# Groundwater Application Review Summary Form

Application # G- 19398

GW Reviewer Steve Ahlquist Date Review Completed: 4/16/2024

TO: Water Rights Section Date 4/16/2024  
 FROM: Groundwater Section Steve Ahlquist  
 Reviewer's Name  
 SUBJECT: Application G- 19398 Supersedes review of \_\_\_\_\_  
 Date of Review(s) \_\_\_\_\_

## Theis Interference Analysis

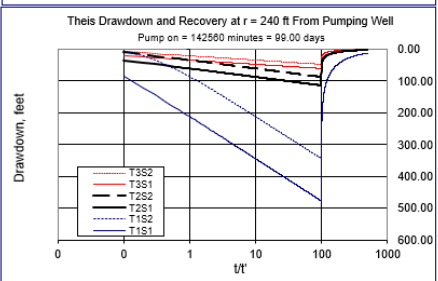
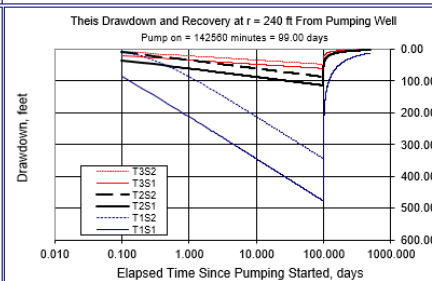
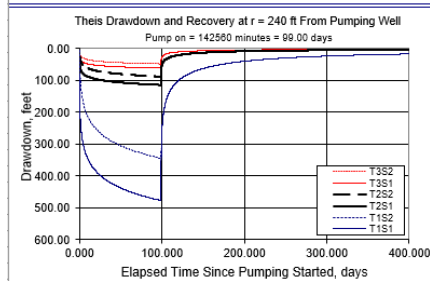
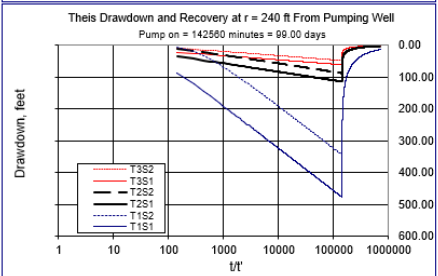
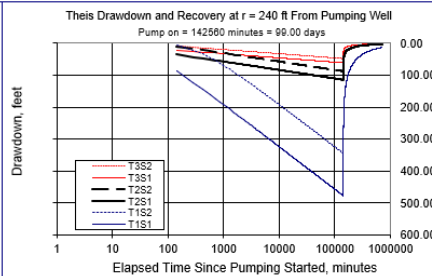
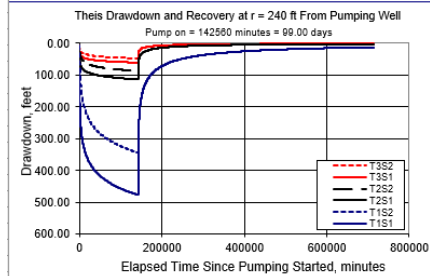
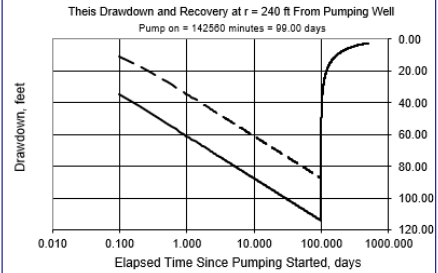
There are several residential properties on adjacent tax lots that are likely supplied by exempt use groundwater wells. The closest residences with potential wells are located approximately 225 feet west of proposed POA 1 and approximately 240 northeast of proposed POA 2. Theis (1935) drawdown analyses were conducted to assess potential well-to-well interference at the potential nearby domestic wells due to pumping at the proposed POAs. Permits issued for nearby POAs contain the standard condition requiring curtailment of pumping when interference with a neighboring well exceeds 25 feet of drawdown; any permit pursuant to this application would be conditioned similarly. Therefore, the potential for interference to nearby wells was evaluated based on the likelihood of well-to-well interference exceeding 25 feet due to pumping at the proposed POAs. Hydraulic parameters used in the Theis analyses are within the typical range of values for the hydrogeologic

regime (Freeze and Cherry, 1979). The applicant did not indicate well-specific rates and annual volumes for the proposed POAs so each well was evaluated individually at the maximum requested rate (0.84 cfs/375 gpm) until reaching the requested annual volume of 164 acre-feet, which would take approximately 99 days. Results of the Theis analyses indicate drawdown at the adjacent residential properties would exceed 25 feet as a result of pumping at the maximum requested rate at any of the POAs. **Due to the expected well-to-well interference, the proposed use is found to not likely be available within the capacity of the groundwater resource.** If the pumping rate was reduced to 0.22 cfs (annual volume [164 sf] spread over 365 days), drawdown would still exceed 25 feet at the neighboring properties as a result of pumping at proposed POA 1 and POA 2. A pumping rate of 0.22 cfs at POA 3 and POA 4 would likely not result in well-to-well interference greater than 25 feet at neighboring properties.

**Stream Depletion (Hunt) Model Analysis**

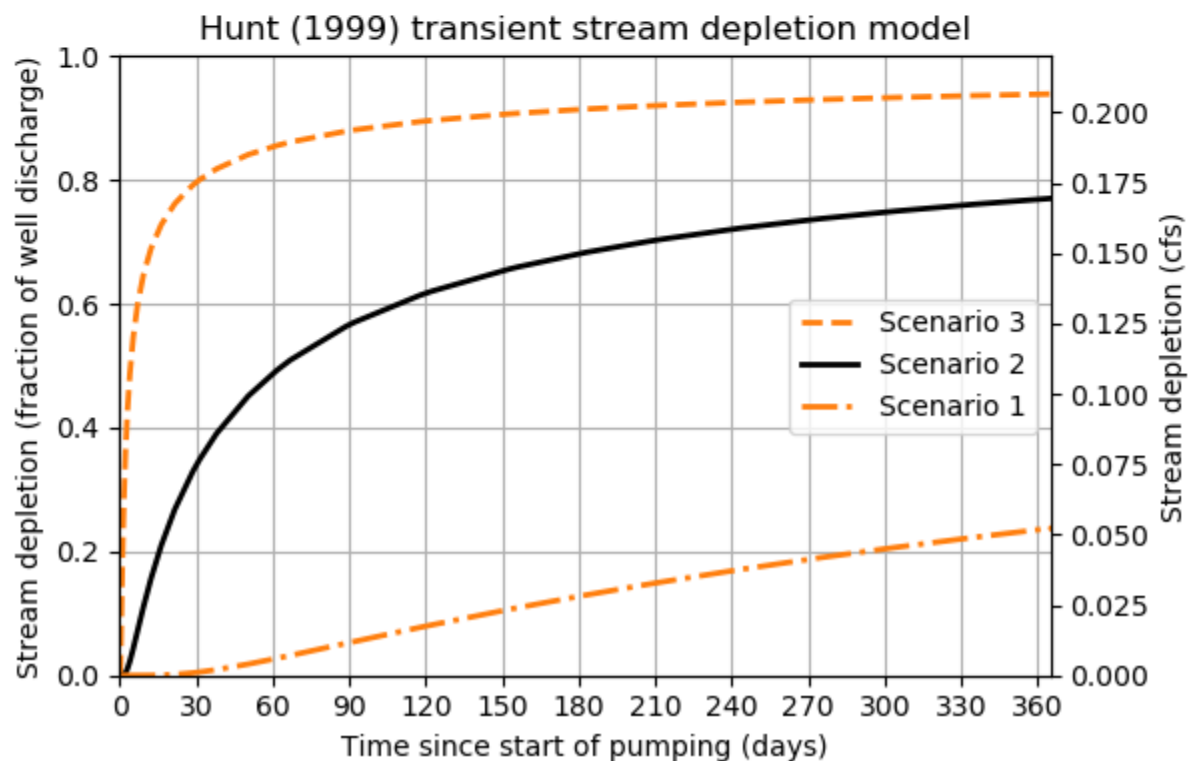
C6. **SW / GW Remarks and Conditions:** Results of the stream depletion (Hunt 1999) modeling indicate the proposed use would result in greater than 25% stream depletion at Whetstone Creek within 30 days of pumping and therefore is found to have the potential for substantial interference (PSI). Reducing the pumping rate would not change the PSI finding for Whetstone Creek. Additionally, stream depletion of Dry Creek would exceed 1% of the 80% exceedance natural streamflow from June through December. **The proposed use is found to have PSI with Whetstone Creek and Dry Creek per OAR 690-009.**
